Adding description for FANUC Robot series R-30iB CONTROLLER
Learning Robot OPERATOR'S MANUAL

Name	FANUC Robot series R-30iB CONTROLLER Learning Robot OPERATOR'S MANUAL
Spec.No./Ed.	B-83534EN/03

Group	Name/Outline	New, Add, Correct, Delete	Applicable Date
Basic			
Optional Function	Some description for Wireless accelerometer is added.	Add	Immediately
Unit			
Maintenance Parts			
Notice			
Correction			
Another

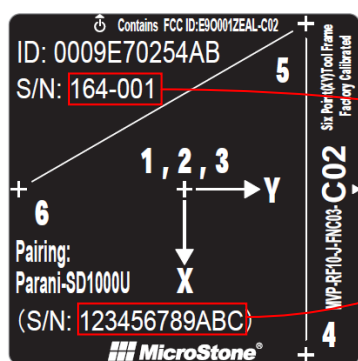
- Wireless ACC SENSOR KIT contains a wireless accelerometer, a USB receiver, and a charging cable.
- One Wireless accelerometer can be used with only one USB receiver which is pairing registered before shipment. You can check which accelerometer (receiver) matches for the receiver (accelerometer) by S/N(Serial Number) printed on label.

Fig. 2.1.2 (b) Dimensions of the USB receiver

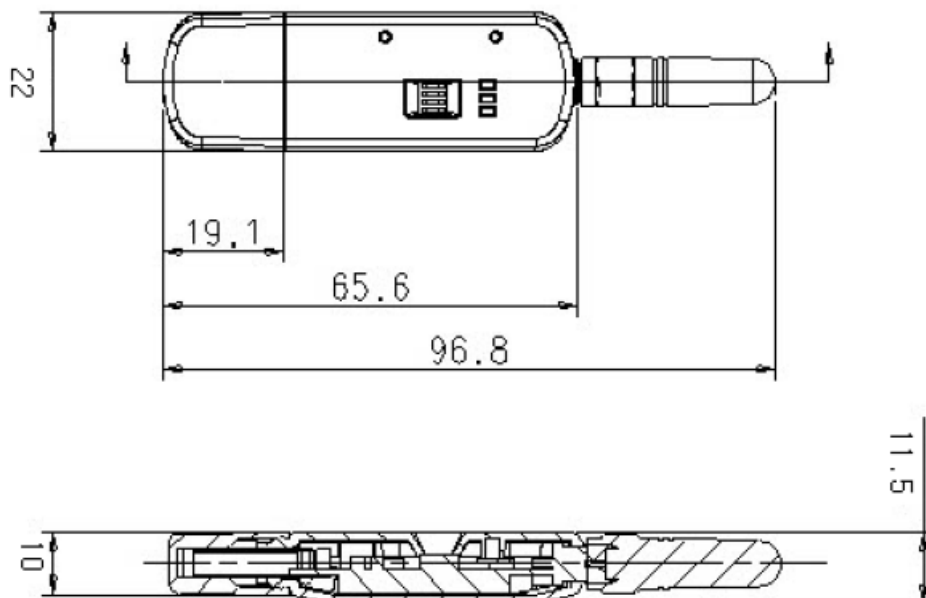
- Please add some description for “2.1.2 Wireless accelerometer” as follows.

**Fig. 2.1.2 (d) LED on USB receiver**

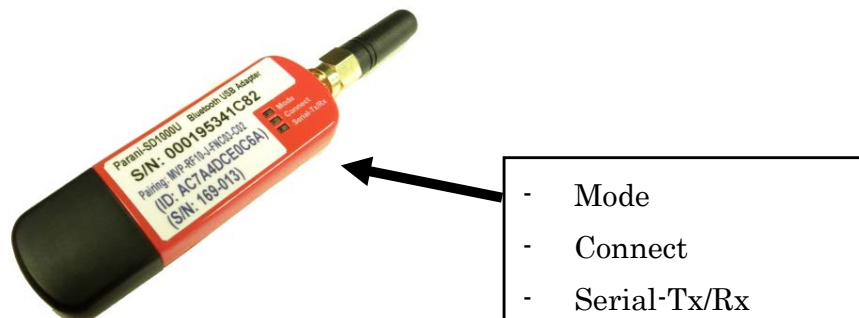
USB receiver has three LEDs that indicate the status of receiver as shown in Fig. 2.1.2 (d).

Fig. 2.1.2 (g) C-clamp Adapter Kit for Wireless Accelerometer

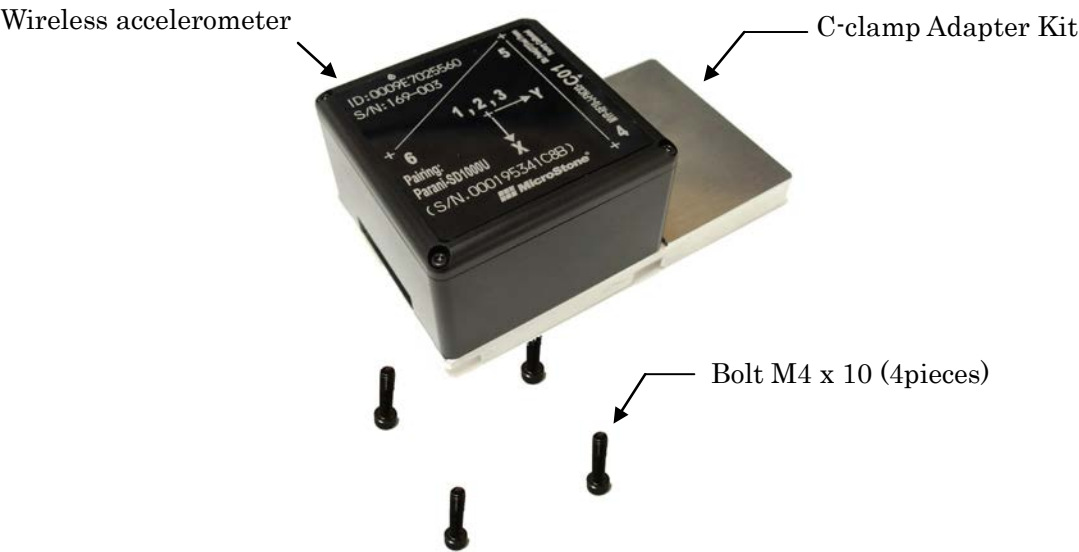
Mount the wireless accelerometer on the adapter kit and tighten the bolts with tightening torque 2.25Nm as shown in Fig. 2.1.2 (g). After that, attach the accelerometer to an end-of-arm tool or servo gun by clamping the plate of the kit with a C-clamp, as shown in Fig. 2.1.2 (h).

Fig. 2.1.2 (h) Clamping an Accelerometer with a C-clamp Kit

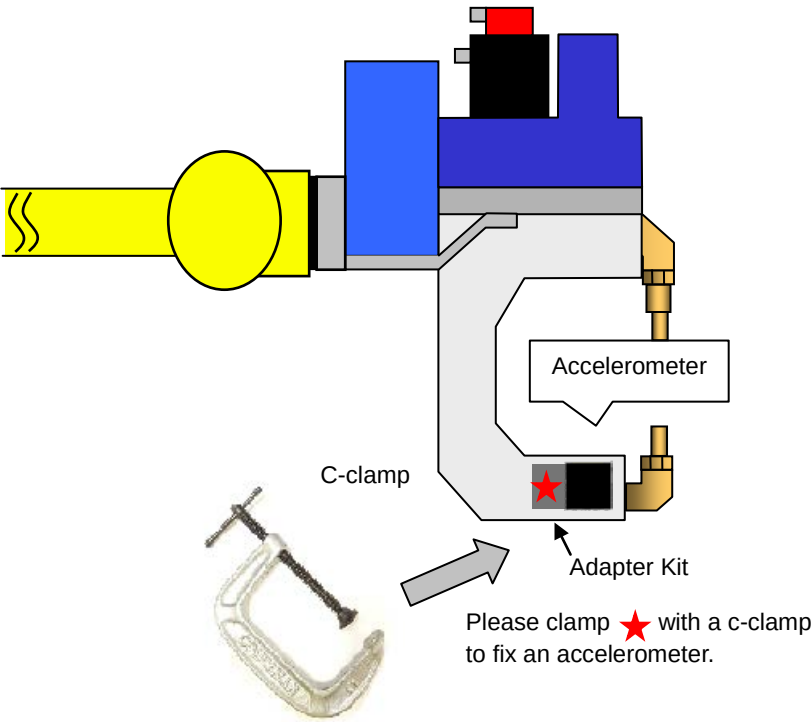
Clamping an accelerometer directly with a C-clamp may deform the accelerometer and cause sensor failure.
